#### APPEAL SUMMARY

<b>Appeal ID:</b> 24648	<b>Project Address:</b> 1906 NW 25th Ave
<b>Hearing Date:</b> 2/24/21	<b>Appellant Name:</b> Dave Spitzer
<b>Case No.:</b> B-011	<b>Appellant Phone:</b> 503 307 4644
<b>Appeal Type:</b> Building	<b>Plans Examiner/Inspector:</b> preliminary
<b>Project Type:</b> commercial	<b>Stories:</b> 2 <b>Occupancy:</b> R-1, B, F <b>Construction Type:</b> V-B
<b>Building/Business Name:</b> Escher Apartments	<b>Fire Sprinklers:</b> Yes - basement
<b>Appeal Involves:</b> occ Change from S to B	<b>LUR or Permit Application No.:</b>
<b>Plan Submitted Option:</b> pdf [File 1] [File 2] [File 3]	<b>Proposed use:</b> business/residential

BASEMENT IMPROVEMENTS  
ESCHER APARTMENTS  
1906 NW 25TH AVENUE PORTLAND, OREGONOWNER:  
BRYAN FRIEL, NEUBURG & FERGUSON L.L.C.  
1231 NW HOYT STREET, ST. 201 PORTLAND, OREGON 97209RDG  
REITER DESIGN GROUP  
ARCHITECTS, INC.

## BASEMENT FLOOR PLAN

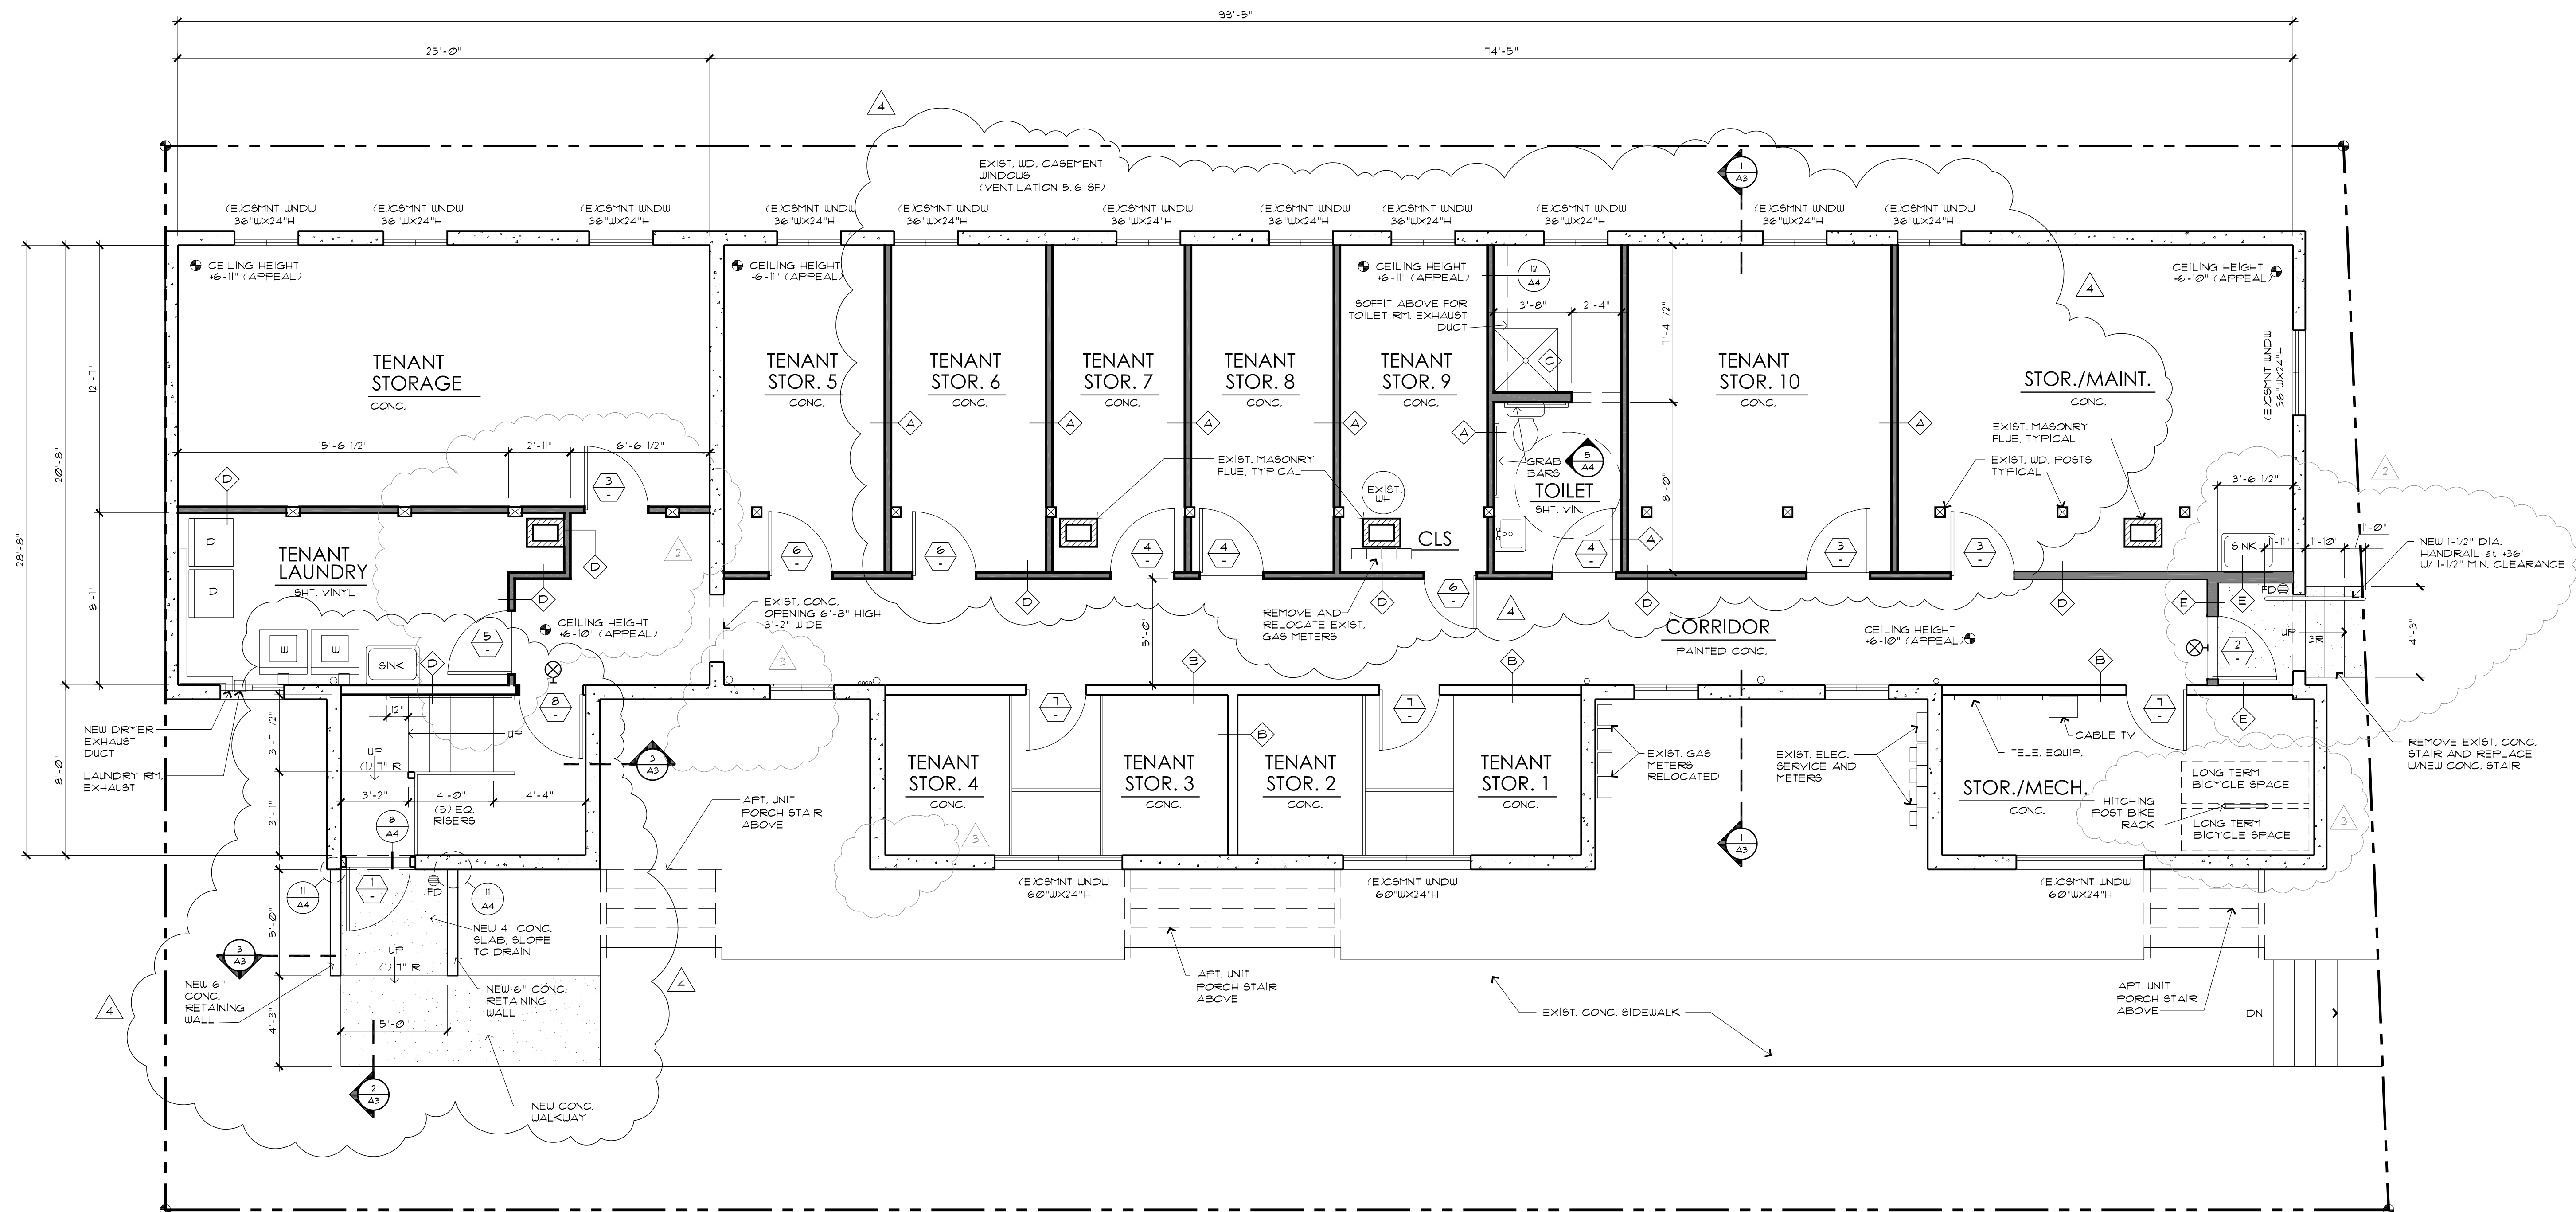
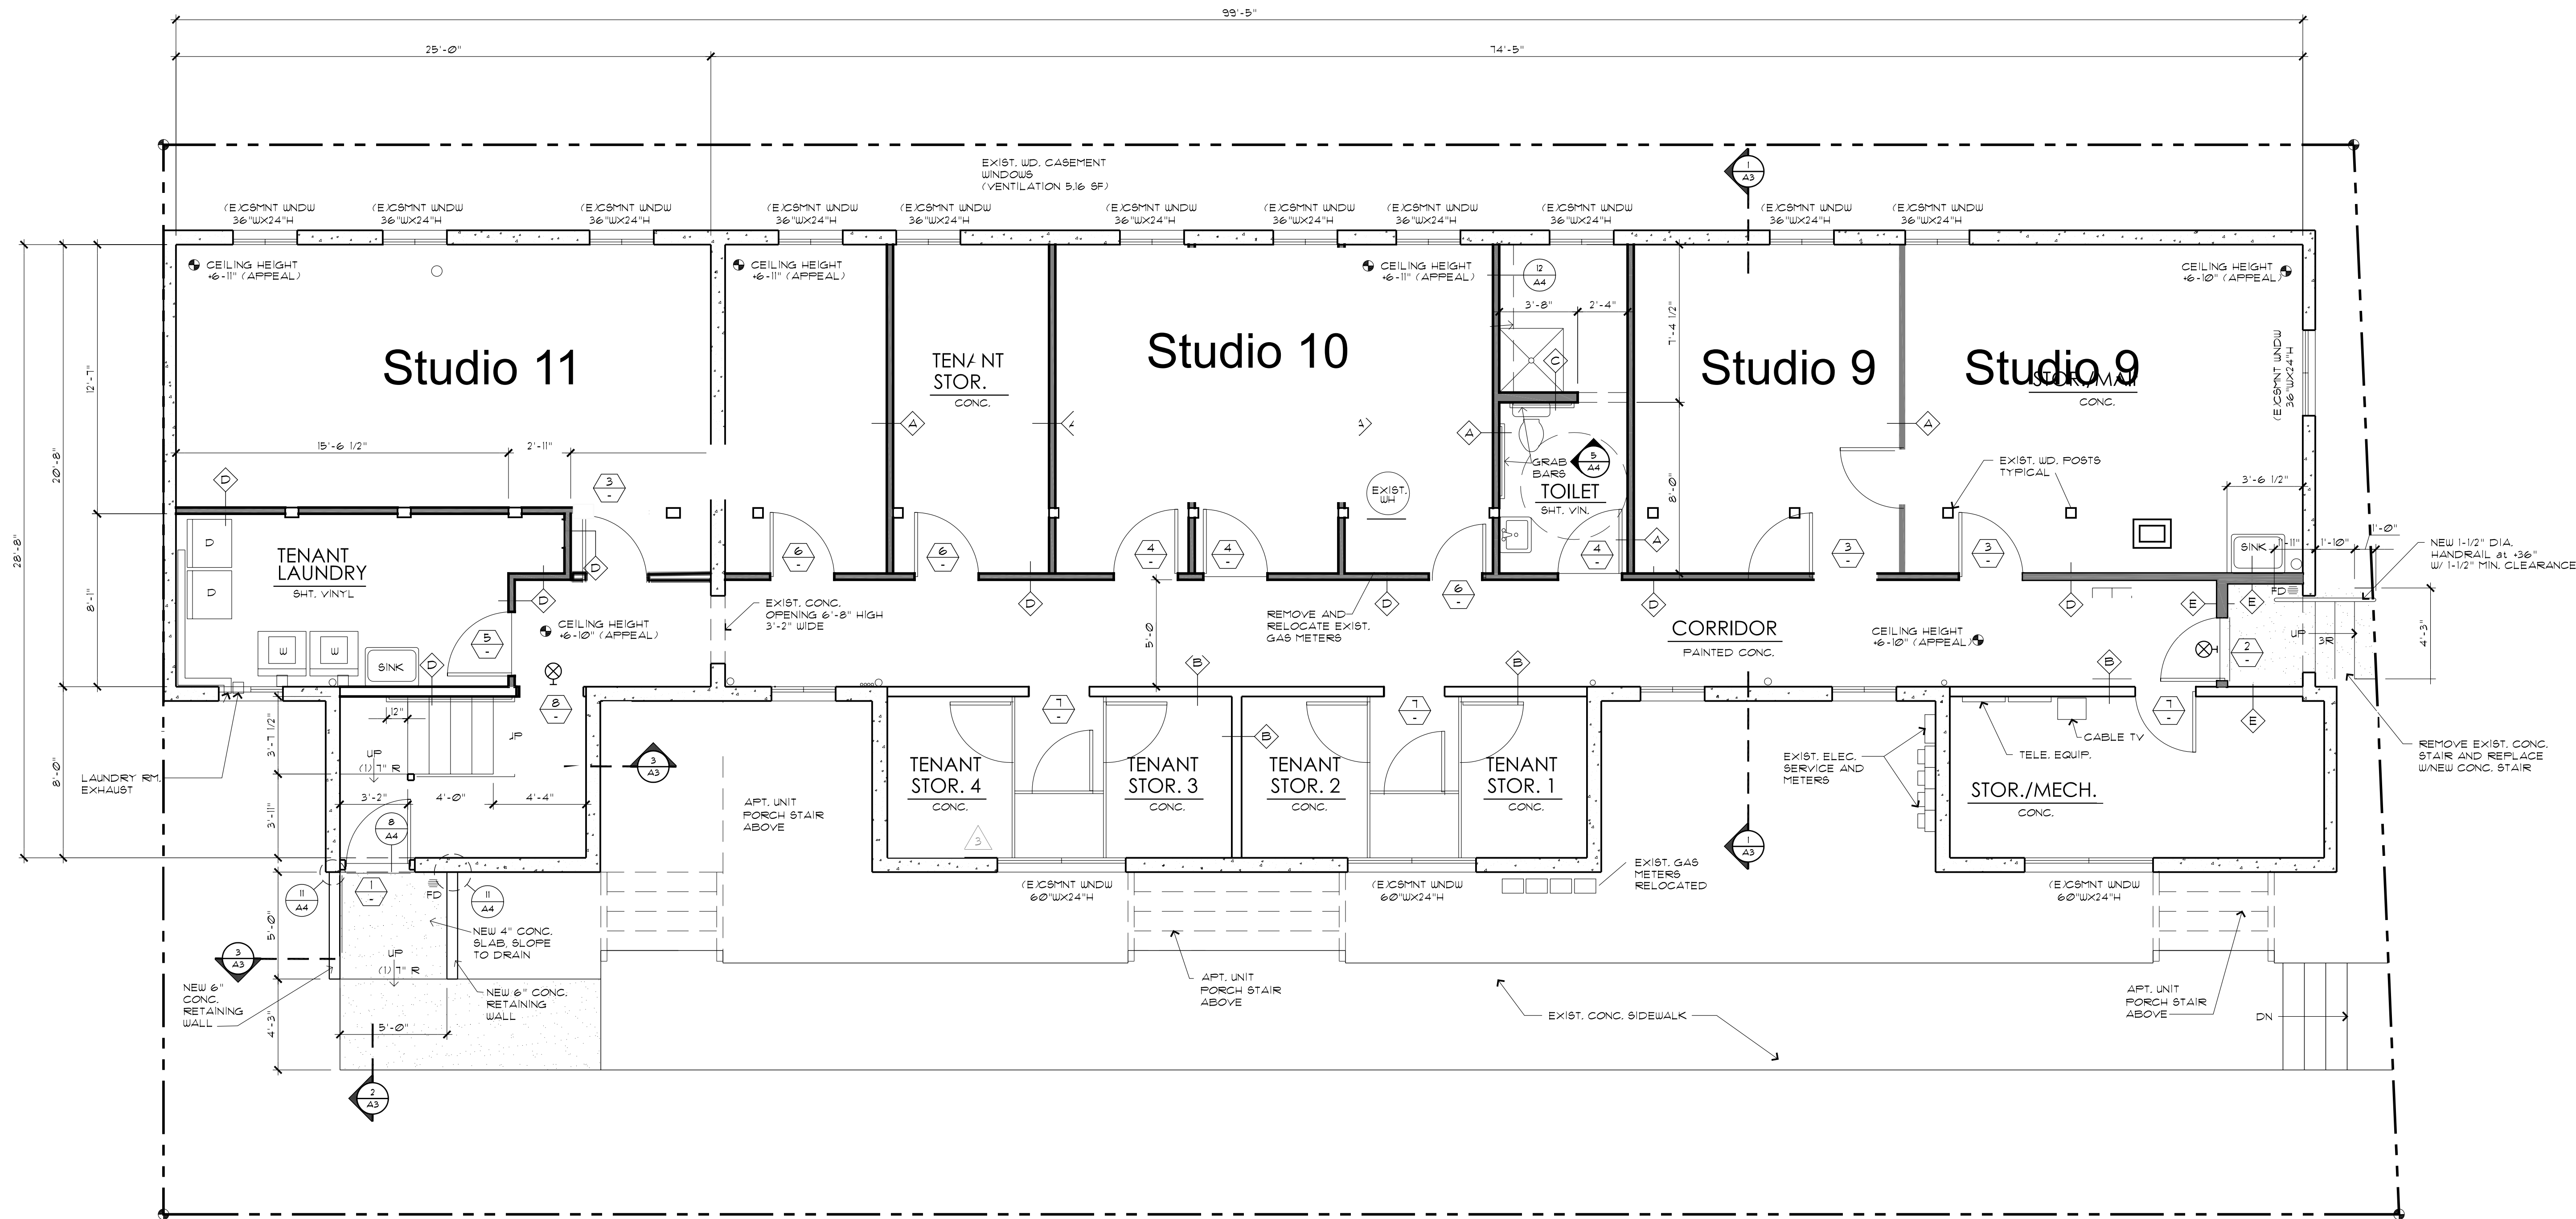
<b>Code Section</b>	OSSC 1207.2
<b>Requires</b>	Requires a minimum ceiling height of 7'-6"
<b>Code Modification or Alternate Requested</b>	<p>To allow a reduced ceiling height of 6'-9" for a B and/or F occupancies in the basement of this apartment building.</p> <p>It should be noted that ceiling height in the egress system of this basement was appealed and granted approval in 2005 per appeal # 1433.</p>
<b>Proposed Design</b>	<p>We are proposing to change approximately 2/3rd of a finished basement currently used for storage into studio spaces for artists and small businesses. The storage rooms were installed in 2009 per permit 2009-117492-CO. The building was originally built in 1908.</p> <p>The ceiling height is an existing situation and the basement is currently used for storage and maintenance purposes. We would like to remove (9) tenant storage spaces, reducing the occupant load, and replace it with (4) studio spaces ranging from approximately 200 sf to 300 sf. The net overall increase in occupant load is very small – perhaps 3-4 people.</p> <p>The type of client that would want this type of space would be massage therapist, photographers, artists, etc. Prospective tenants would not be looking for luxury space or a destination space – just a simple, affordable space in close in NW Portland.</p>

<b>Reason for alternative</b>	<p>Appeal #1433 already allows reduced ceiling height in the stairs and circulation route in this basement. This appeal would simply extend that ceiling height reduction into the newly created artist studios. Since the circulation route already has a legal reduced ceiling height – we do not feel that extending that head height will increase the life safety hazard or make the building any less safe. To us this seems more like a quality of space issue - not a safety issue.</p>

<b>Code Section</b>	OSSC 903.2
<b>Requires</b>	Requires a NFPA 13 sprinkler system to be installed in R1 occupancies.
<b>Code Modification or Alternate Requested</b>	To allow approximately 2/3rds of the existing basement to be converted from storage units to artist units (office, massage therapist, artists).
<b>Proposed Design</b>	<p>Apparently, in going over historic records with the current property owner, we discovered that appeal #1433 from 2004 required sprinklers to be installed in the basement - that never happened. The 2004 appeal also references 'artists studios' – but I do not see any reference to that in the 2009 drawing that I have (I was not able to obtain the actual permit drawings -but by the dates – I believe the attached are what was approved).</p> <p>Per this appeal and subsequent permit – we would construct 'artist studios' (office, massage therapist, artists – no sleeping areas). And install a sprinkler system in the basement of this building.</p>

<b>Reason for alternative</b>	<p>We feel the addition of sprinklers in this building will improve the overall life safety of the building. An occupied basement with sprinklers is safer than a non-occupied basement with no sprinkler system in our opinion. If the board feels additional fire or smoke detection would be helpful, the owner would be willing to install that to go above and beyond minimum code.</p> <p>Part of the proposed upgrade will include upgrading the floor/ceiling separating the basement from first floor apartments to meet current fire and sound requirements as well.</p>

**Proposed Design** The subject area is an existing basement space that has a clear height of 6'-10" to 6'-11" with the floor slope. With the addition of new 5/8" type 'X' gypsum board to the floor/ceiling assembly, the finish height will be 6'-9 3/8" to 6'-10 3/8".

The two new exit doors will have a height of 6'-8" and the doorway opening in the existing concrete wall in the Corridor is 6'-8".

**1. Reduction in minimum required ceiling height from 7 feet 6 inches to 6 feet 9 inches: Hold for additional information. See note below regarding the process for submitting additional information.**

**2. Installation of fire sprinklers in basement change of occupancy: Hold for additional information. See note below regarding the process for submitting additional information.**

**1. Basement ceiling height: Granted provided that if the basement is not currently sprinklered, full coverage will be required under permit from the Fire Marshal's Office.**

**2. Headroom at existing stairway: Granted as proposed.**
